AGENDA ELLETTSVILLE PLAN COMMISSION Zoom Meeting Thursday, March 4, 2021 - 6:00 P.M.

PC 21-06 – Preliminary Plat Staff Report

PC 21-07- Preliminary/Final Plat Staff Report

PC 21-02 – Preliminary Plat Staff Report

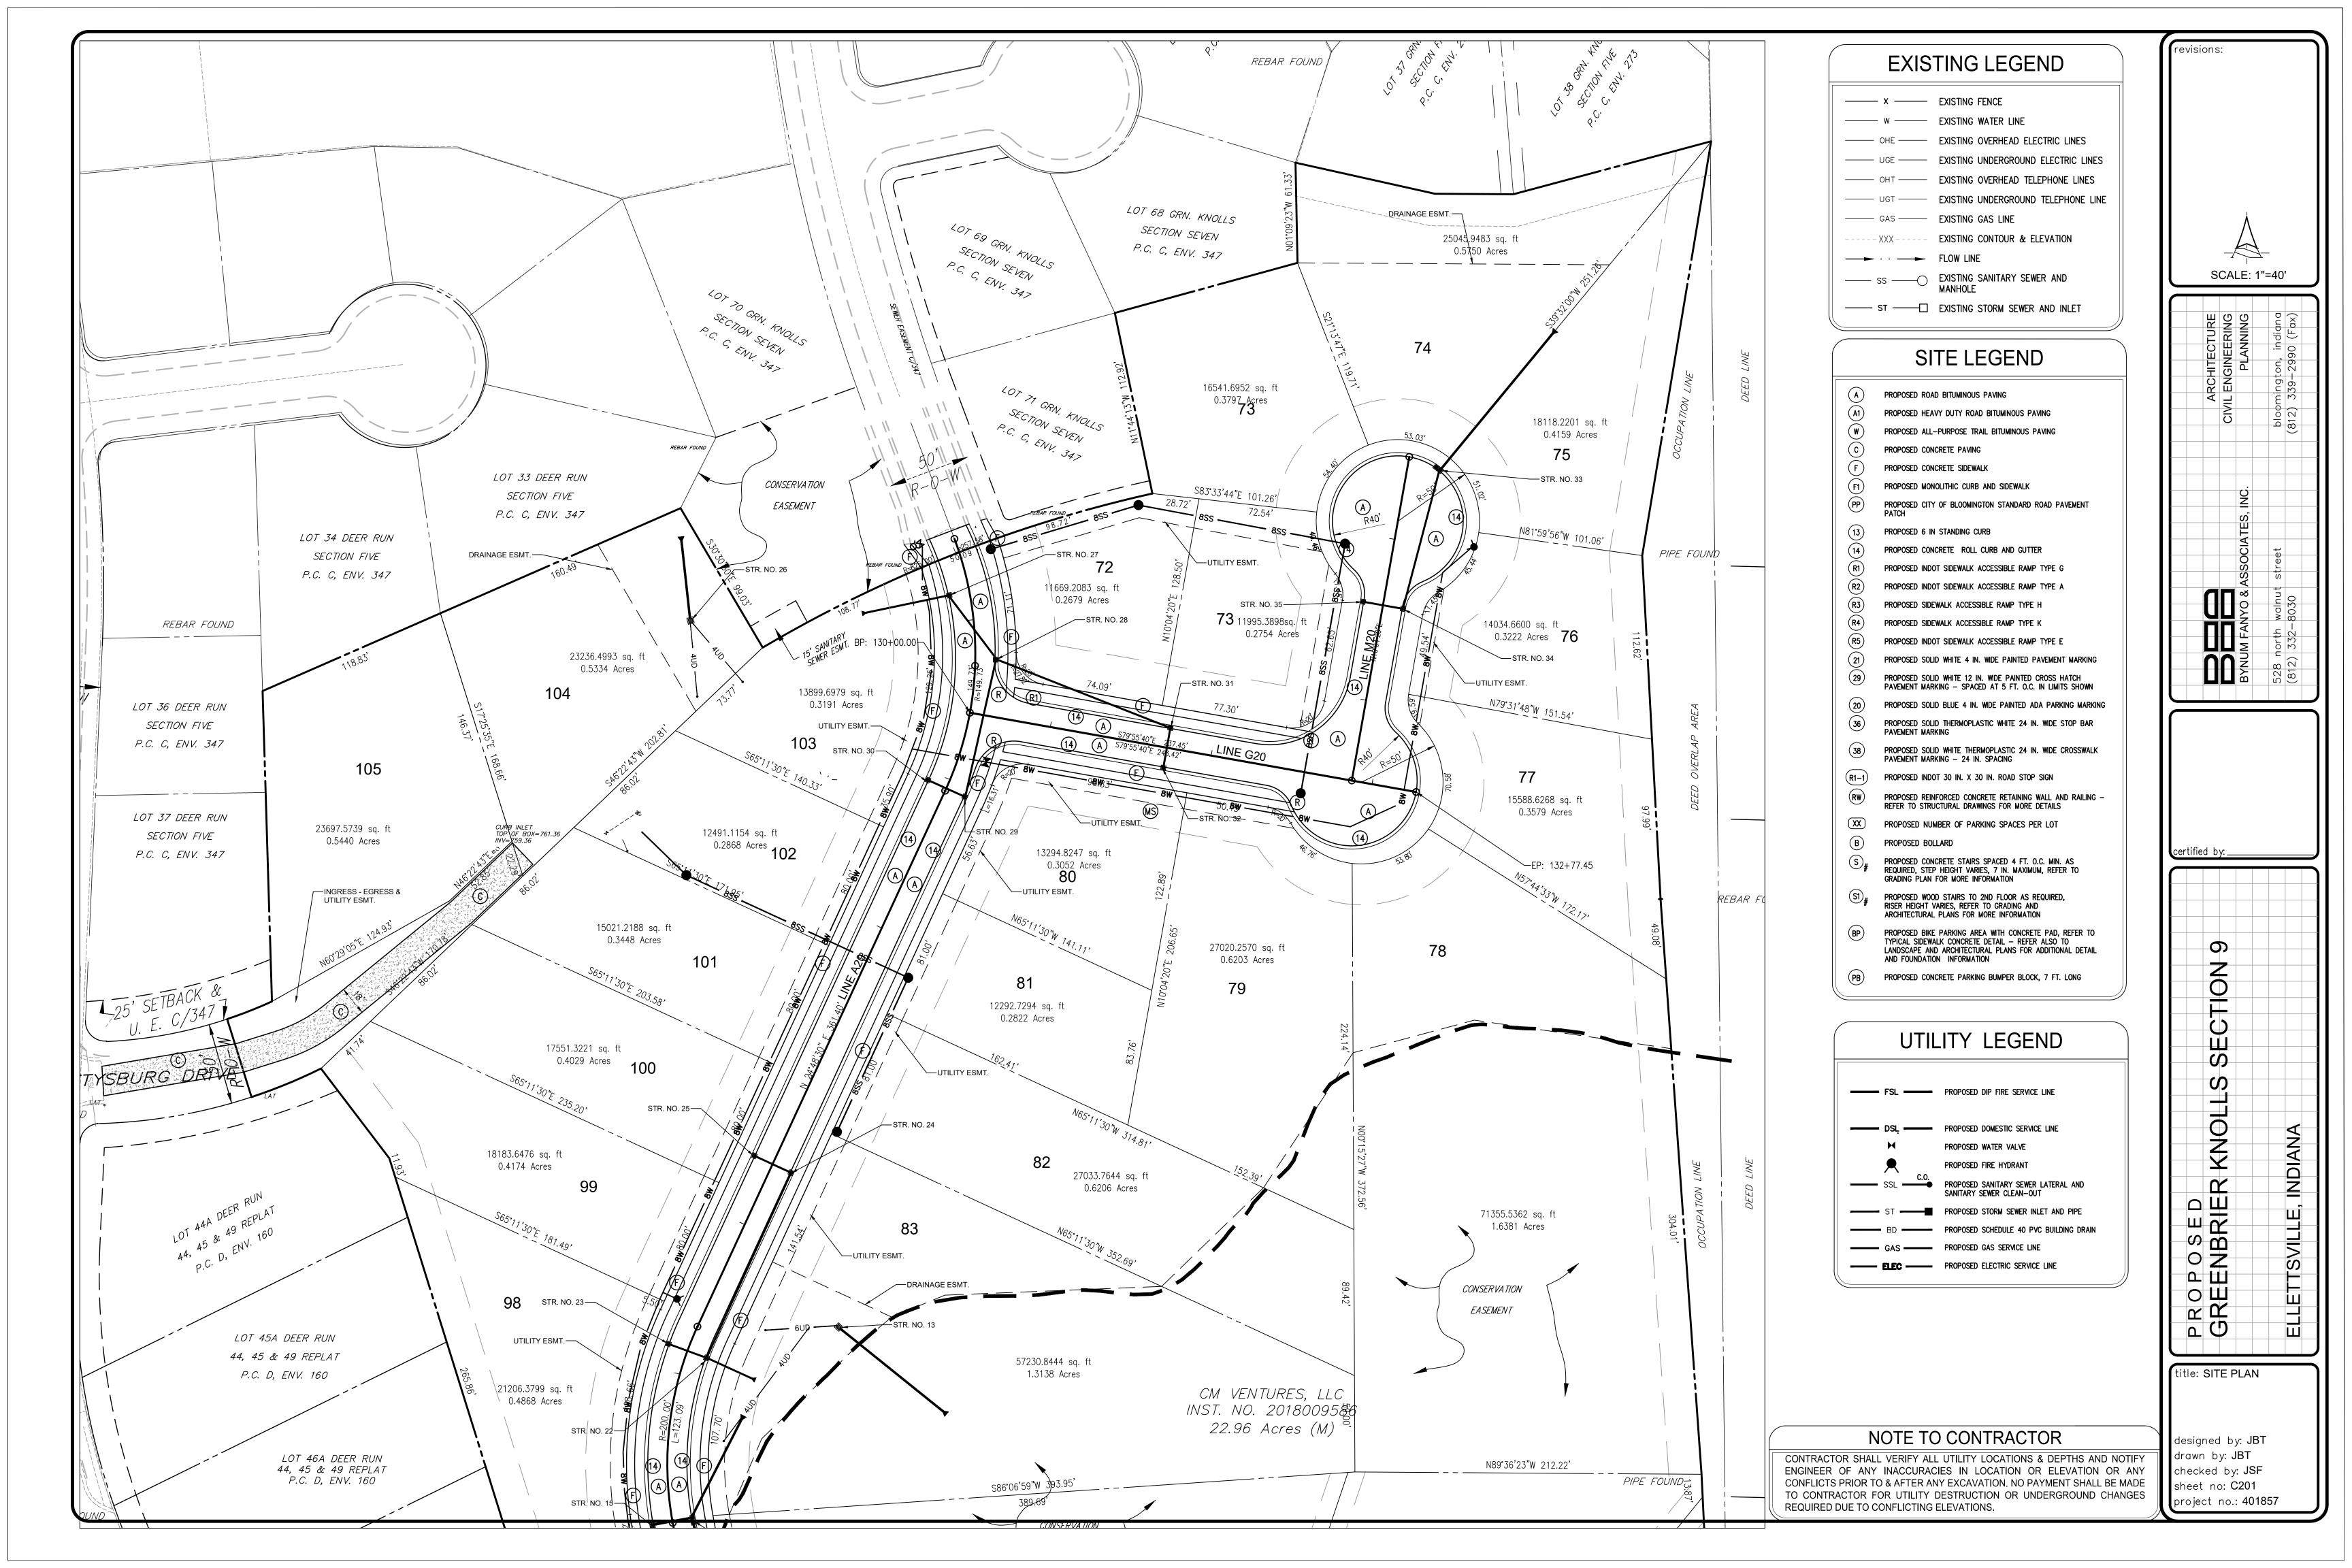
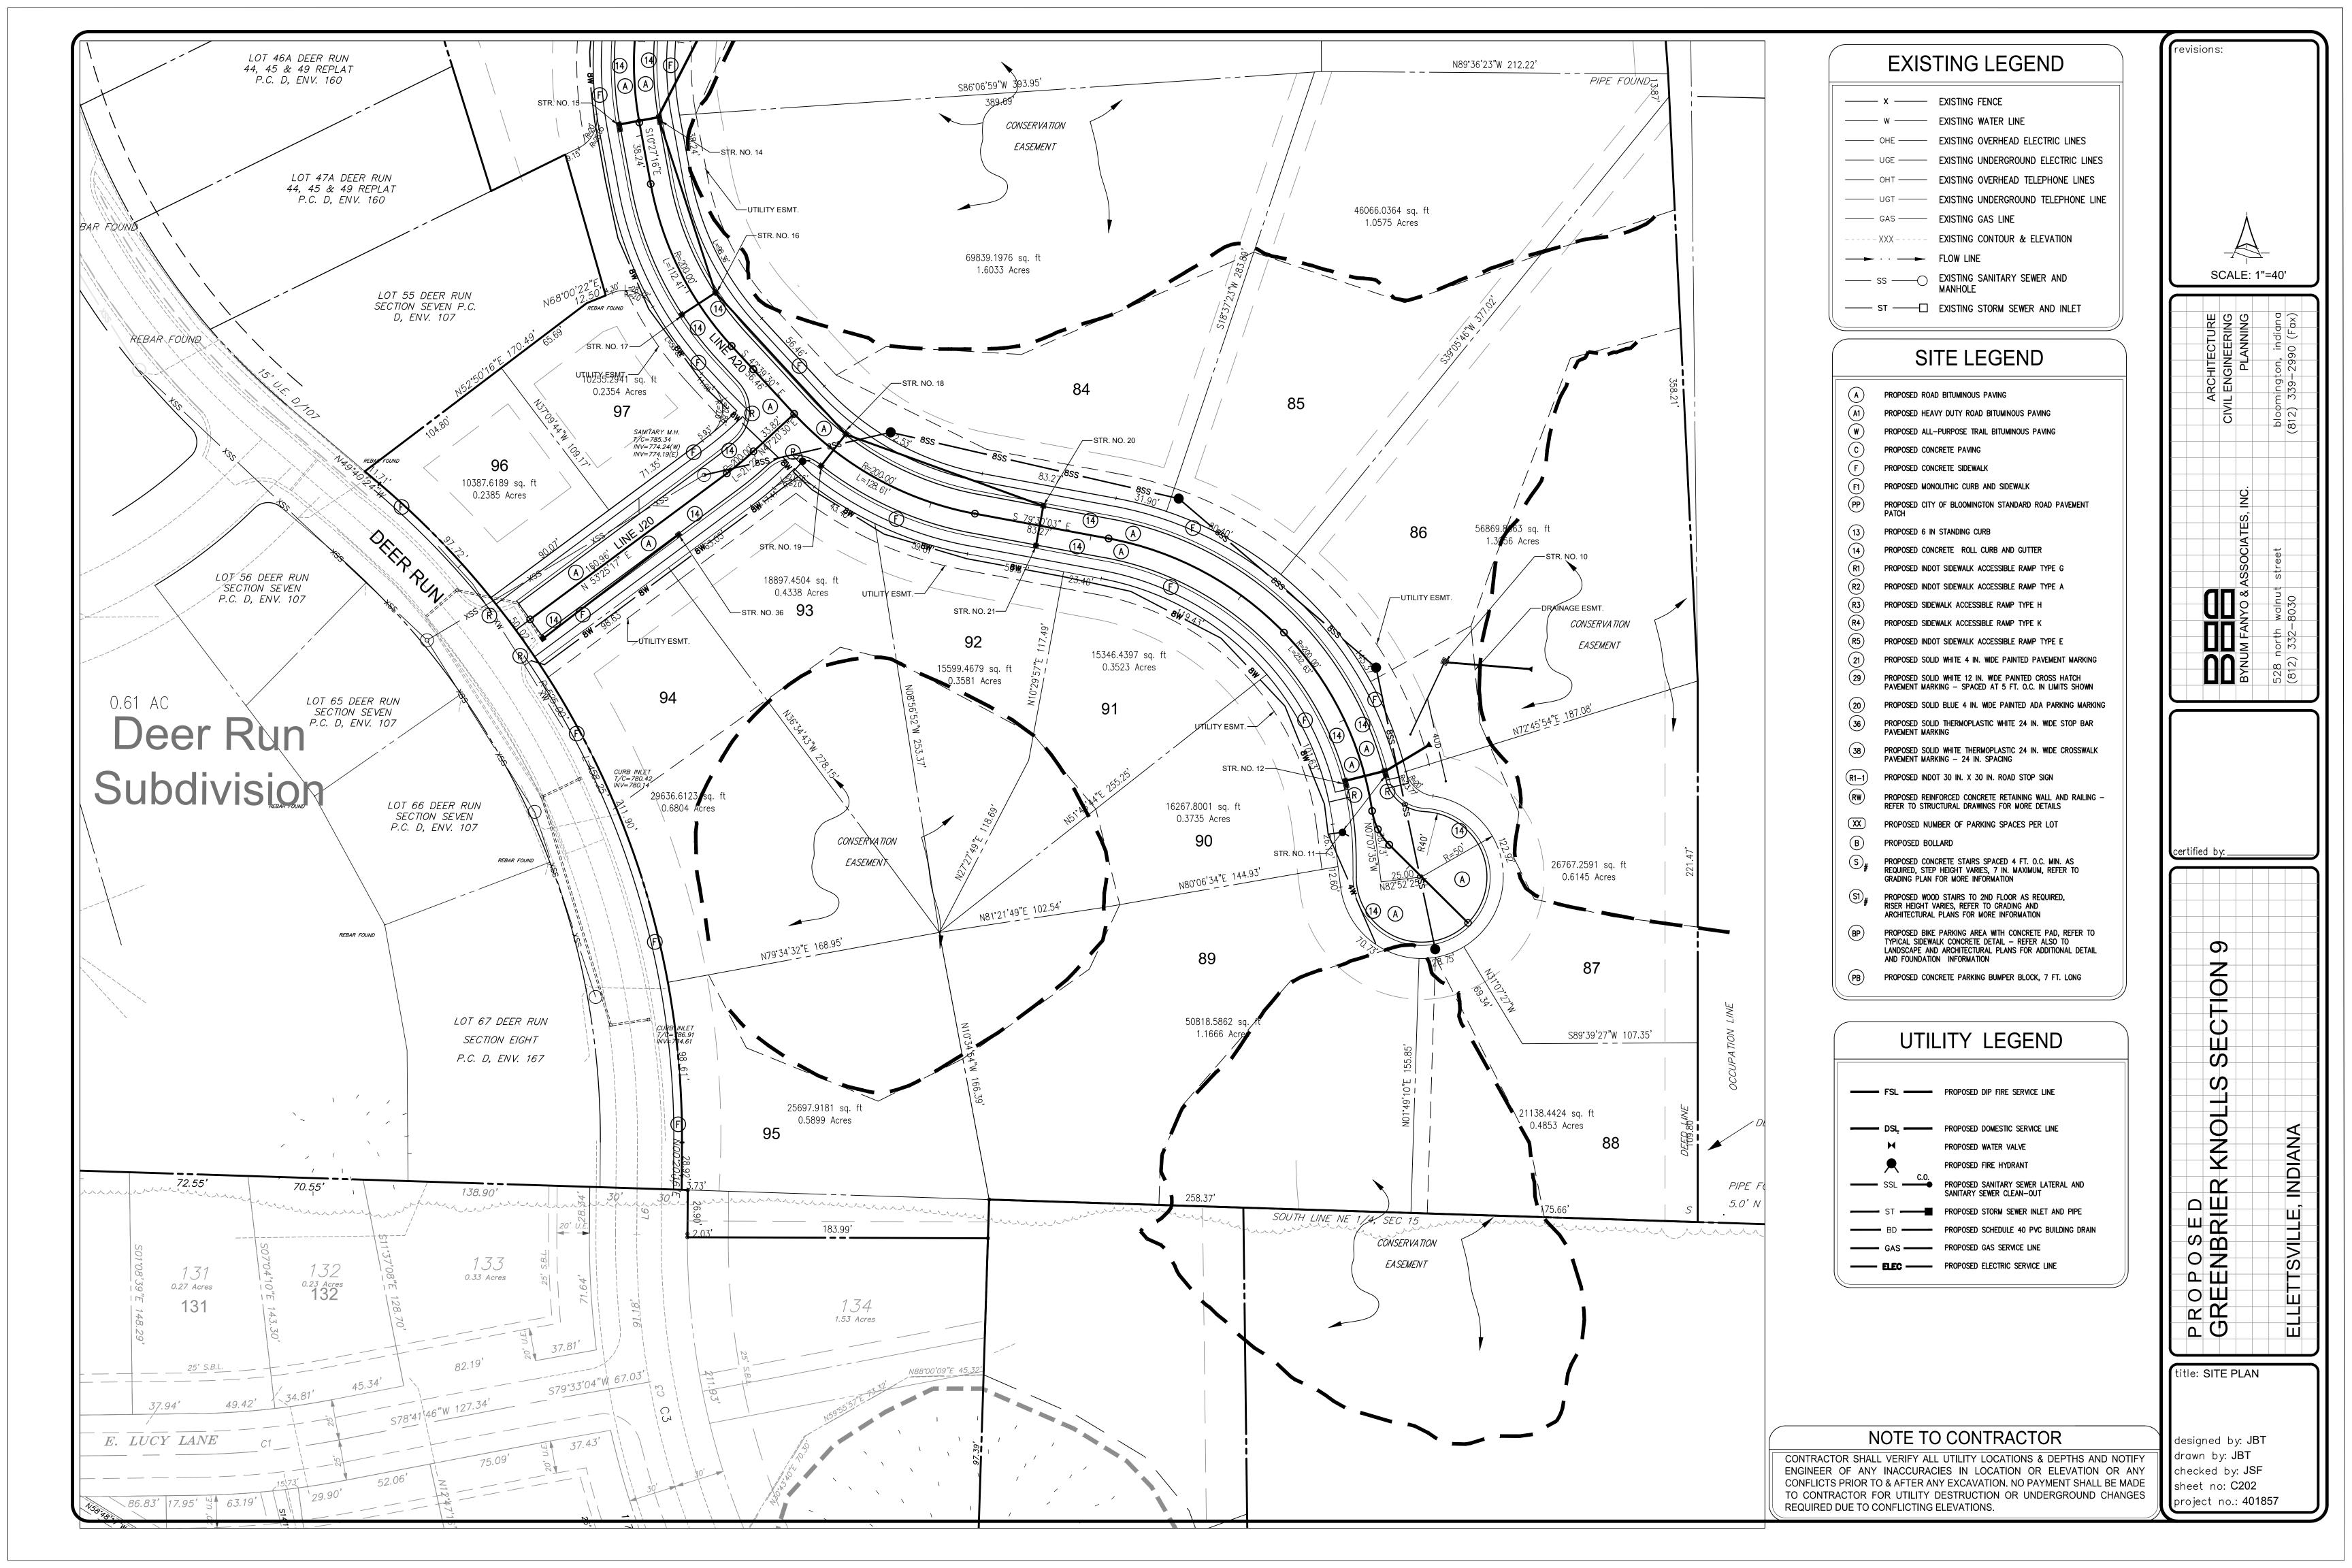
3. Please show any proposed utility/drainage/access easements.
